Addendum

No. 01
Date: 01-24-2025
Project: Clackamas Fire District Training Center
Architect: Scott Edwards Architecture, LLP
 2525 E. Burnside Street
 Portland, Oregon 97214
 Phone: (503) 226-3617
 Fax: (503) 226-3715

G1.01

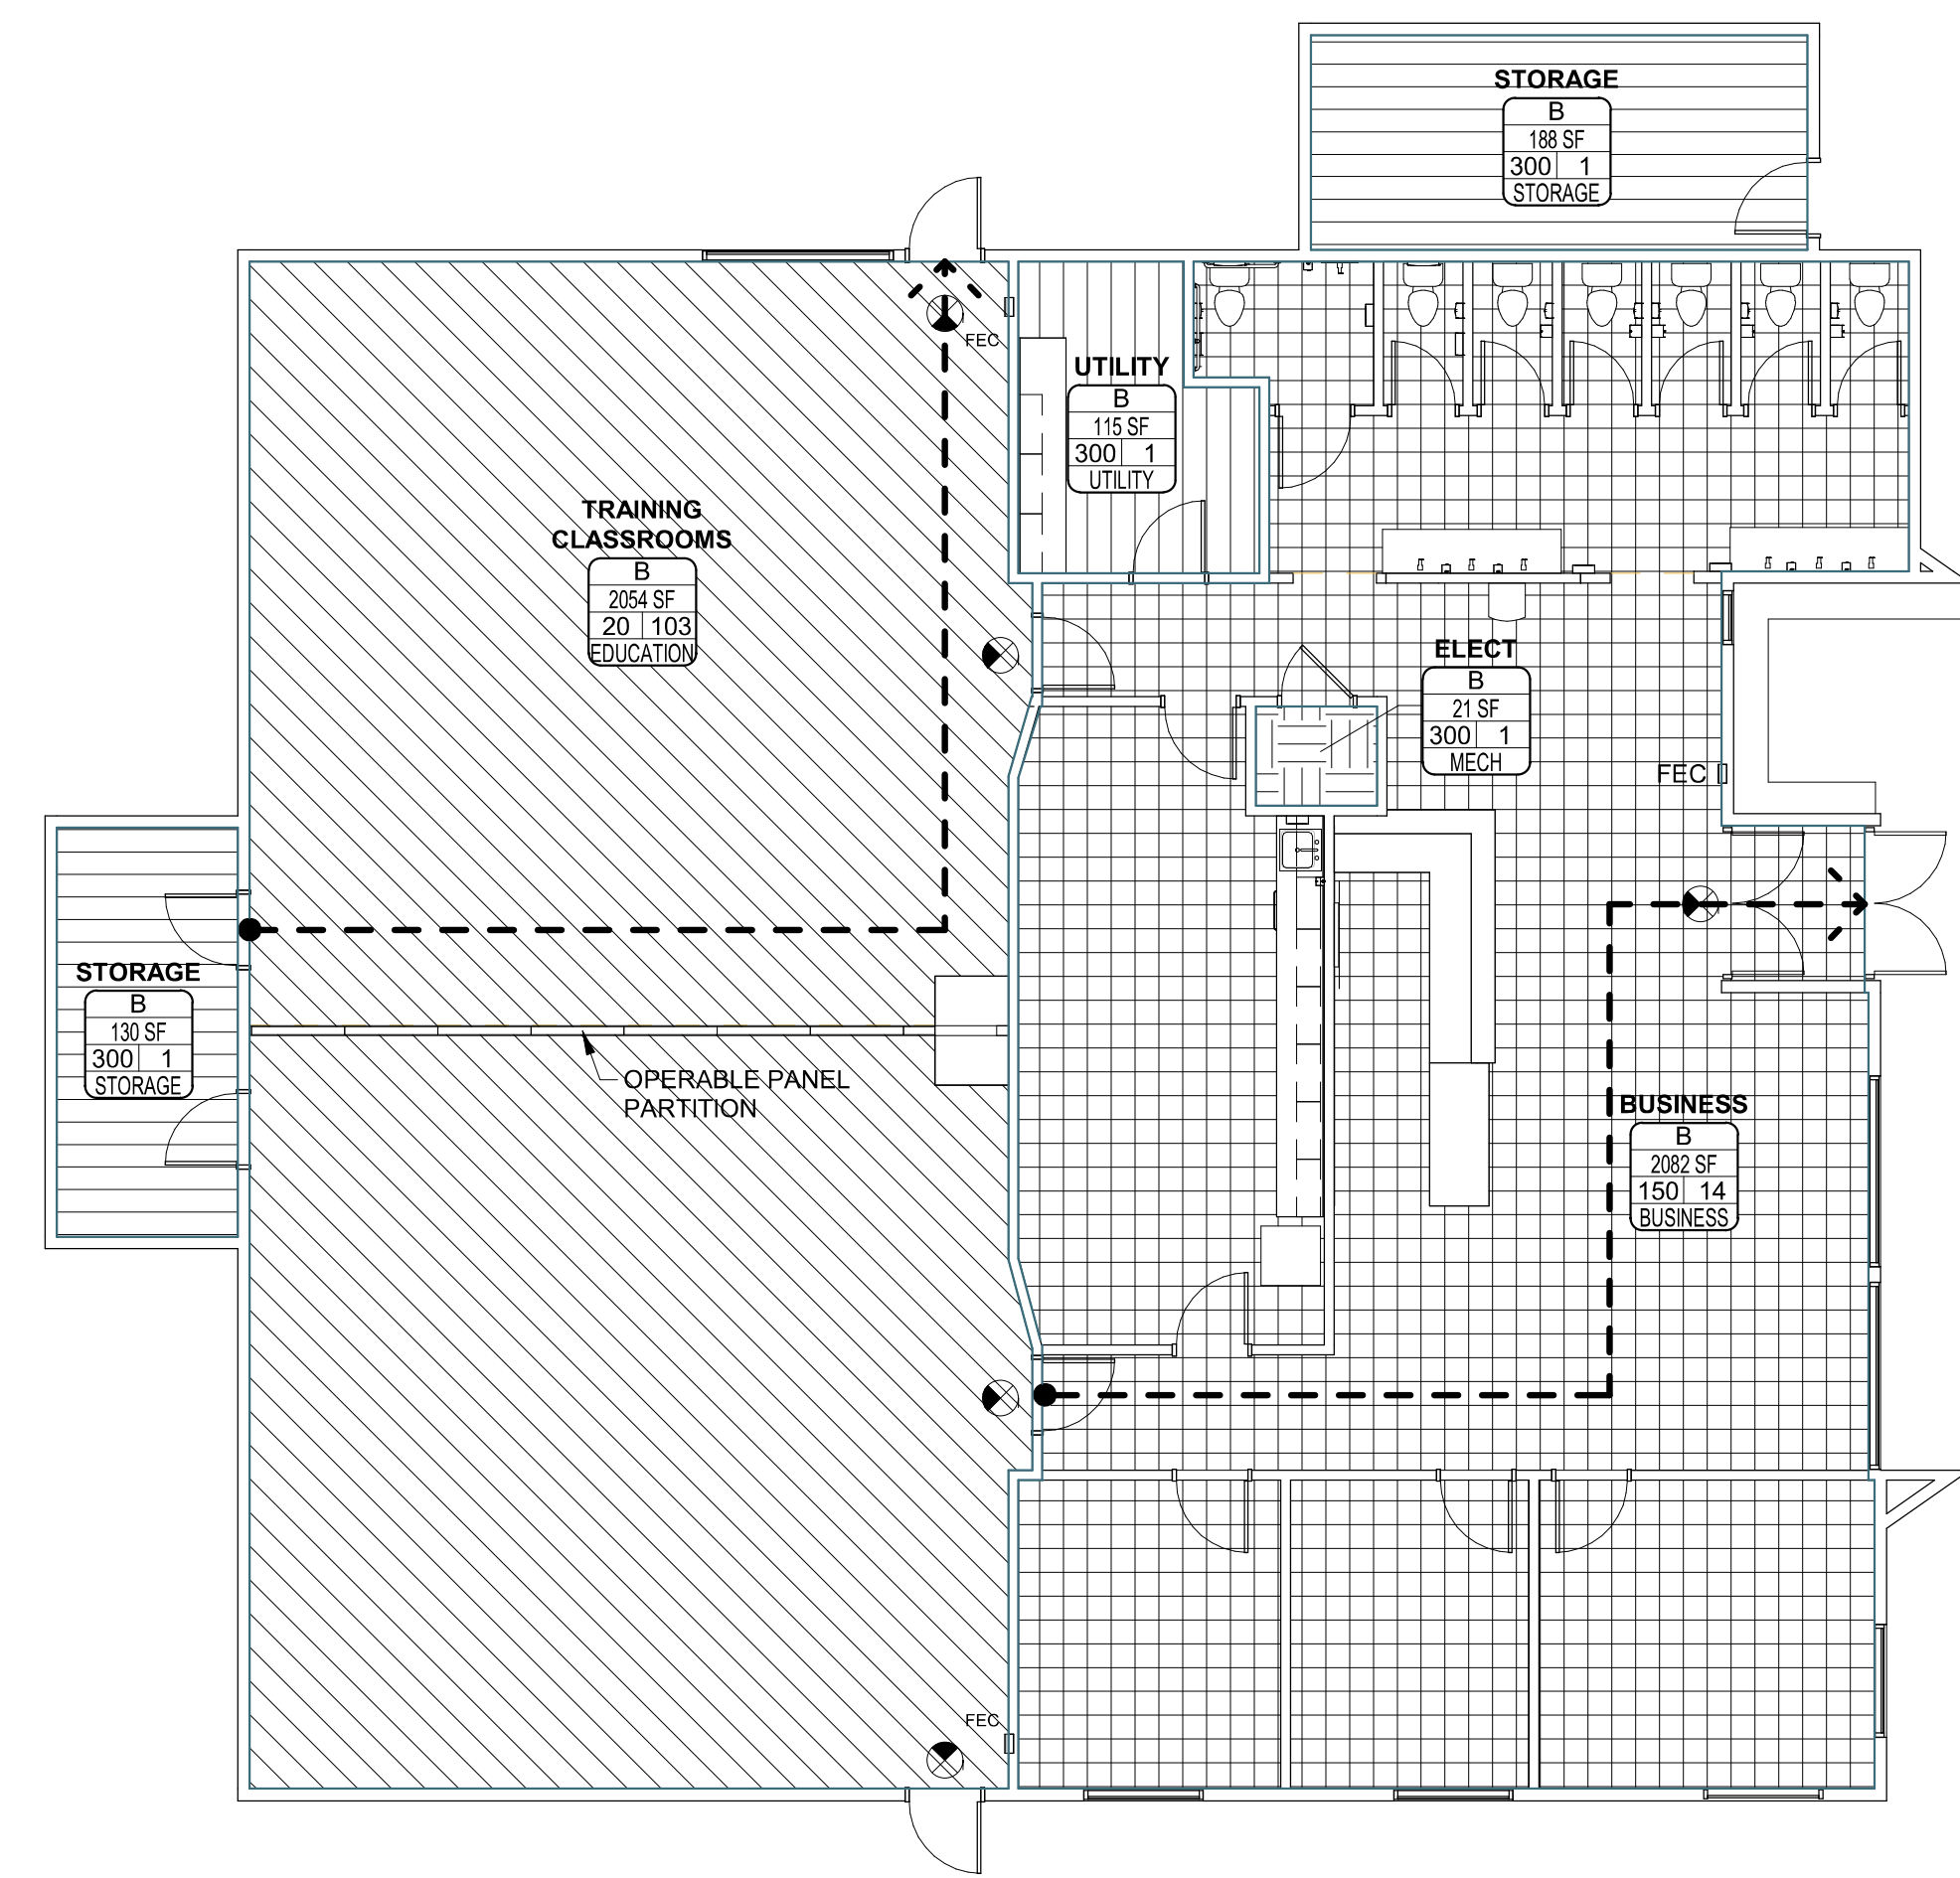
Sheet G0.01	<ol style="list-style-type: none"> 1. Deductive Bid Alternates #1 thru #3 added: 2. Delegated / Bidder Design Items list modified removing the Fire Sprinkler System and Fire Detection and Alarm System from the list. These systems are not included in the scope of work. 3. Deferred Submittal list modified removing the Fire Sprinkler System and Fire Detection and Alarm System from the list.
Sheet G1.01	<ol style="list-style-type: none"> 1. Building Code Summary, Construction Type modified to list the building as "Not Sprinklered". 2. Chapter 5: General Building Heights and Area, Building Area modified to list maximum building area.
Sheet A2.11	<ol style="list-style-type: none"> 1. Reverse operable panel partition operation to stack at north wall 2. Revise Note at Reflected Ceiling Plan omitting the reference to Sprinkler Piping above the ceiling.
